# CITY OF ALBUQUERQUE

**Re: Mister Carwash**  
**4709 ALAMEDA BLVD NE**  
**Traffic Circulation Layout-DFT Approval**  
Engineer's/Architect's Stamp 06-21-24 (C17D002A26C)

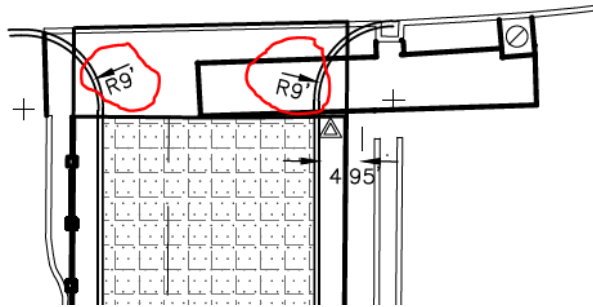
8. The ADA accessible spaces must include an access aisle. Van accessible aisles should be 8ft wide; all others should be 5ft wide.
9. The ADA access aisles shall have the words "**NO PARKING**" in capital letters, each of which shall be at least one foot high and at least two inches wide, placed at the rear of the parking space so as to be close to where an adjacent vehicle's rear tire would be placed. (66-1-4.1.B NMSA 1978)

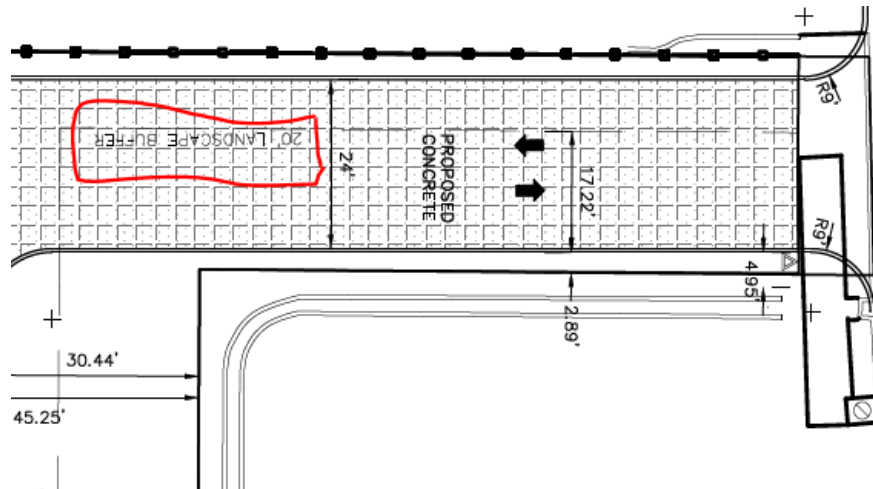
10. ADA curb ramps must be updated to current standards and have truncated domes installed.
11. 9' radii is not enough. Make it 20'.

12. Is this a typo mistake?

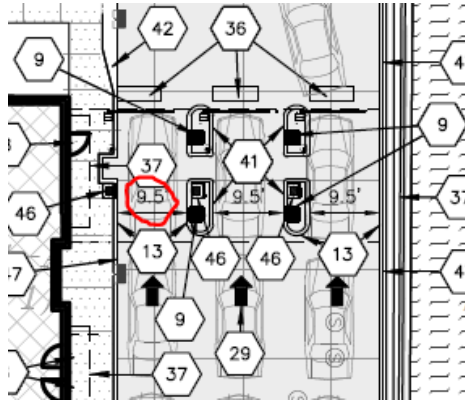
13. Per the DPM, a 6 ft. wide ADA accessible pedestrian pathway is required from the public sidewalk to the building entrances. Please clearly show this pathway and provide details.
14. All one-way drives shall have "One Way" and "Do Not Enter" signage and pavement markings. Please show detail and location of posted signs and striping.
15. The minimum drive through lane width is 12 feet with a 25 foot minimum radius (inside edge) for all turns. (A 15 foot radius can be used with an increase in lane width to 14 feet). 9.5' is very narrow.

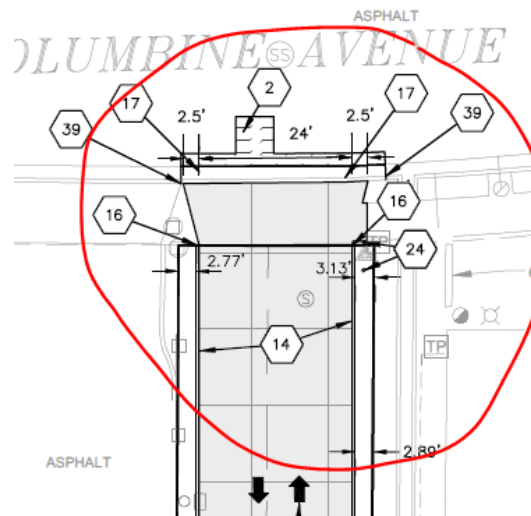
16. Please provide a sight distance exhibit
17. Show the clear sight triangle and add the following note to the plan: "Landscaping and signage will not interfere with clear sight requirements. Therefore, signs, walls, trees, and shrubbery between 3 and 8 feet tall (as measured from the gutter pan) will not be acceptable in the clear sight triangle."

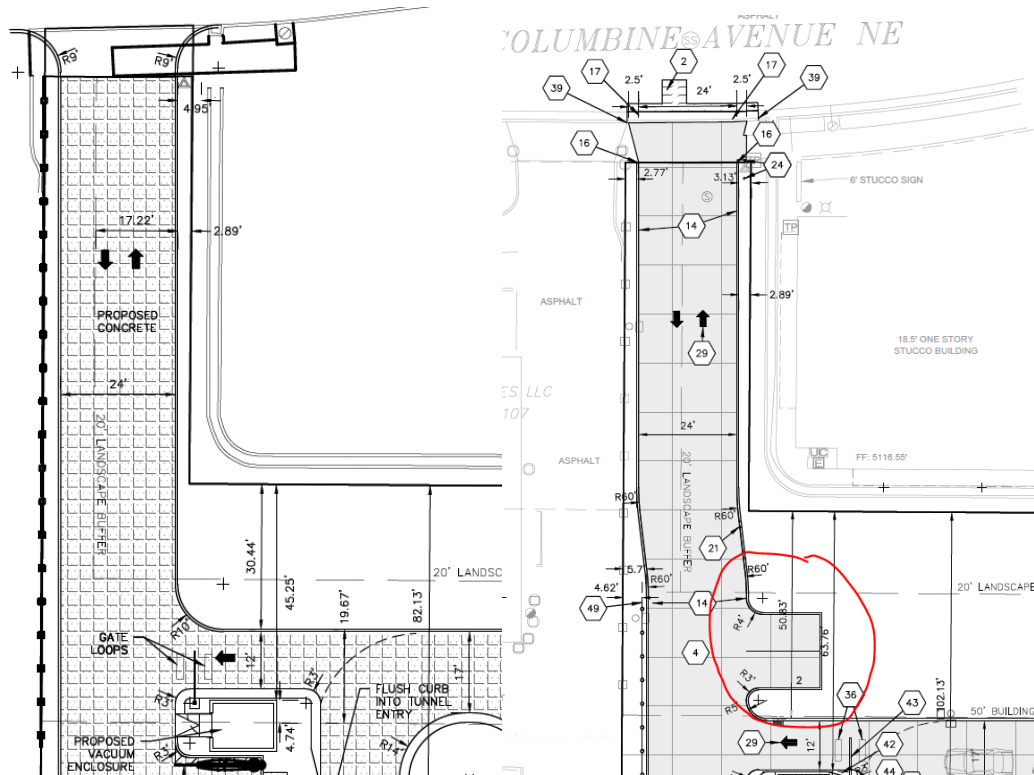
18. Please specify the City Standard Drawing Number when applicable.
19. Shared Site Access: driveways that straddle property lines, or are entirely on one property but are to be used by another property, shall have an access easement. Please include a copy of your shared access agreement with the adjacent property owner.
20. Add a note stating "All broken or cracked sidewalk must be replaced with sidewalk and curb & gutter." A build note must be provided referring to the appropriate City Standard drawing.
21. There is variation in plan at the highlighted location below:

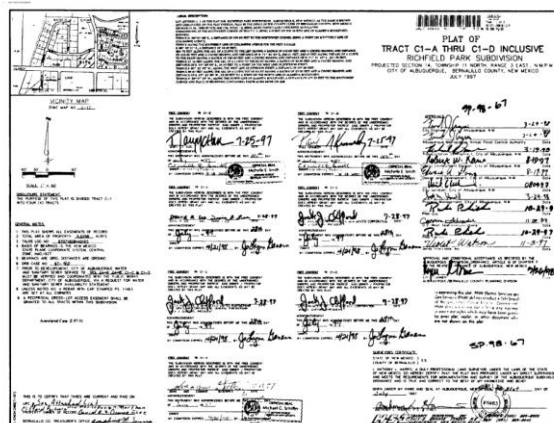
22. Show location of overhead utility lines in relationship to the buildings.
23. Please provide the readable copy of this sheet:
